**Re: Letter of Notification of PPL Electric Utilities Corporation, Filed Pursuant to 52 Pa. Code Chapter 57 Subchapter G, for Approval to Re-terminate Approximately 600 feet of the Existing Lackawanna-Shickshinny 500 kV Transmission Line in Blakely Borough, Lackawanna County, Pennsylvania
Docket No. A-2018-2647063**

**PPL Electric Utilities Corporation
Response to Data Requests of
The Bureau of Technical Utility Services
Dated February 22, 2018
Docket No. A-2018-2647063**

Figure 1: EXISTING & PROPOSED STRUCTURES

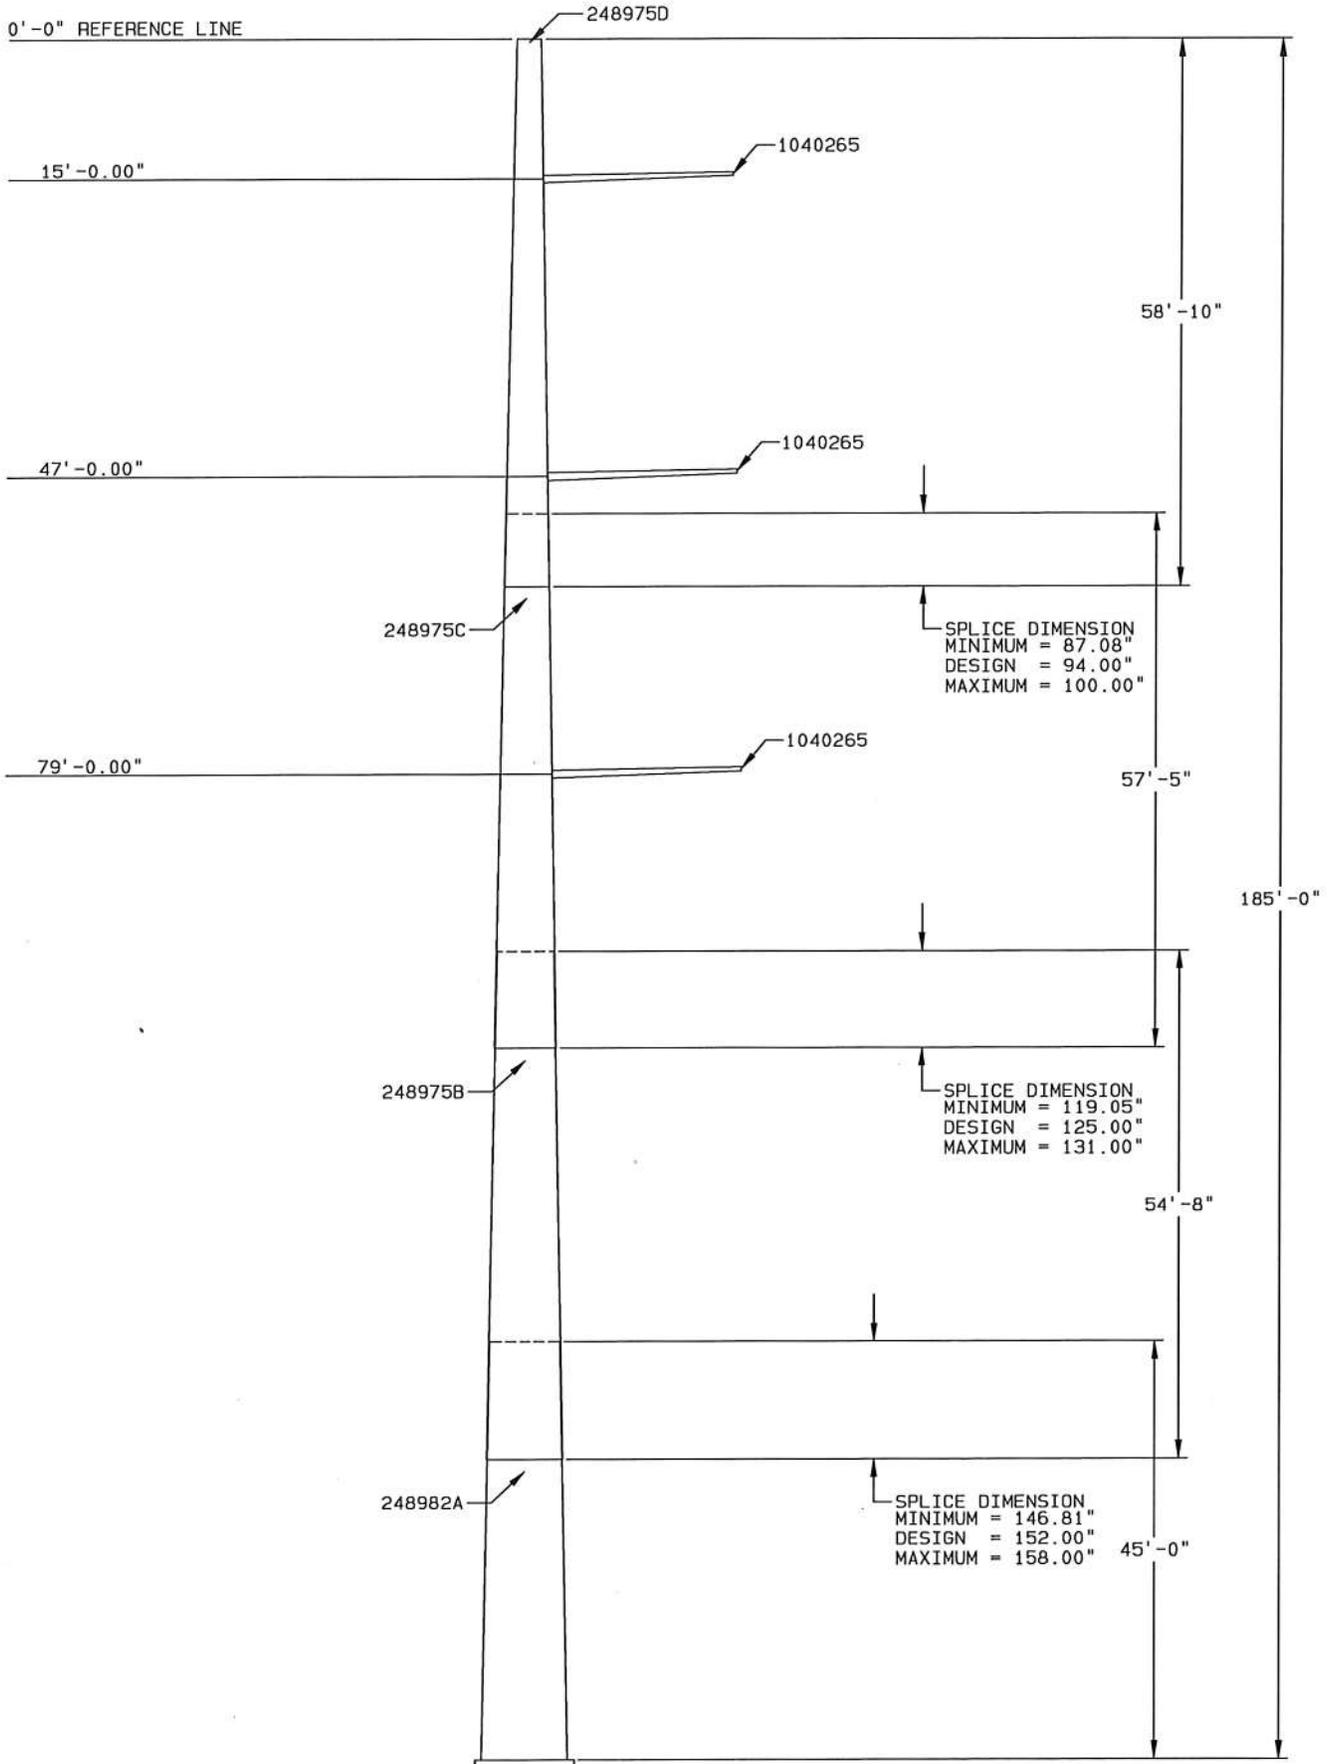
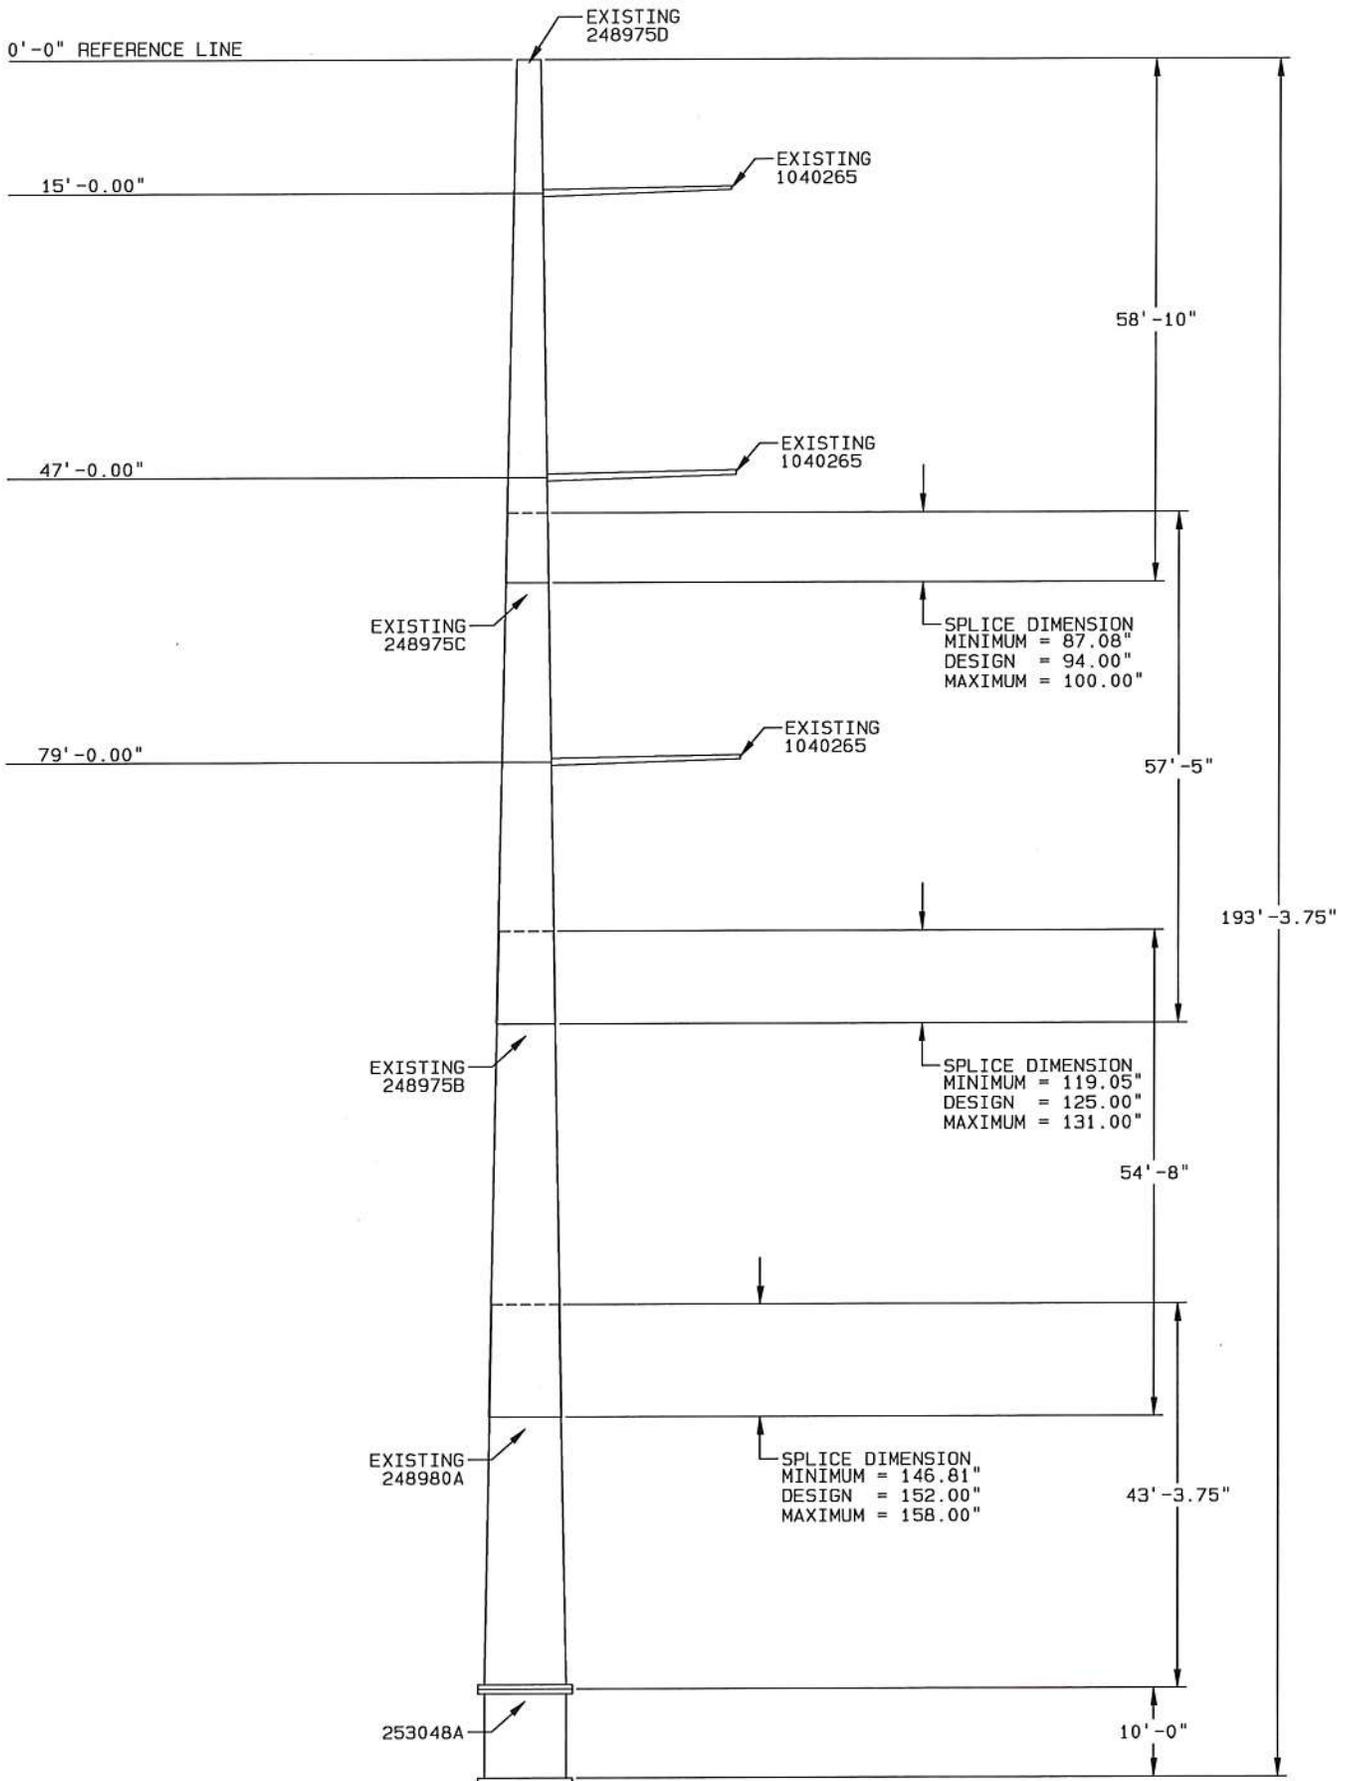
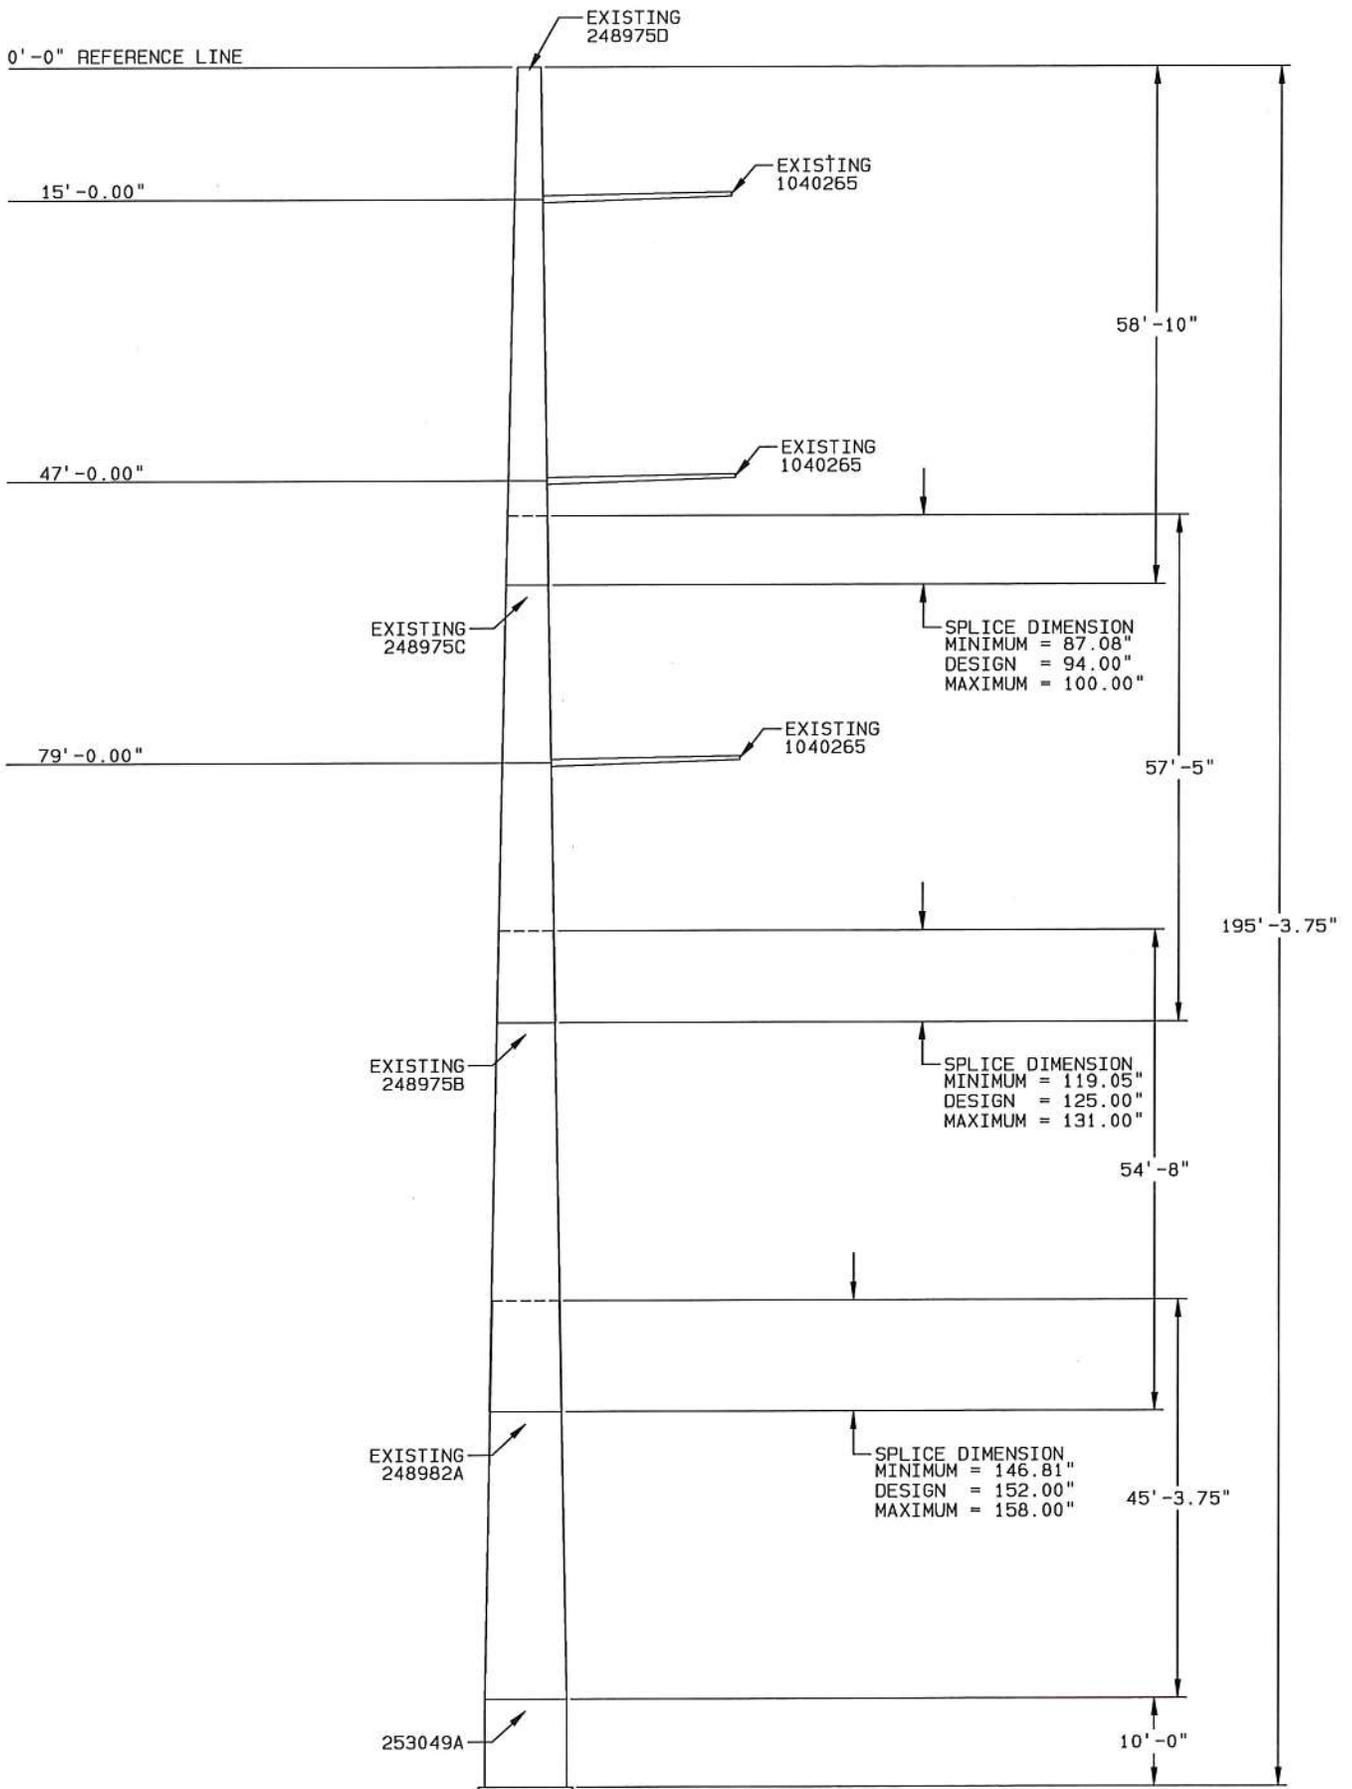
Q.3 Reference the Letter of Notification, Attachment 2, Pages 2-3 – Please state the height of existing nearby transmission tower structures.

A.3 The existing nearby transmission tower structures range in height from 174 feet to 195 feet (see Attachment A.3, structures B7-74 left and right and B7-75 left and right). Additionally, due to recent revisions to the project design, the new structure will be higher than presented in the February 22, 2018 LON. The height of the new structure will be 198 feet, rather than 160 feet as stated in the LON. A revised structure drawing is provided in Attachment A.3 (see structure B7-76).
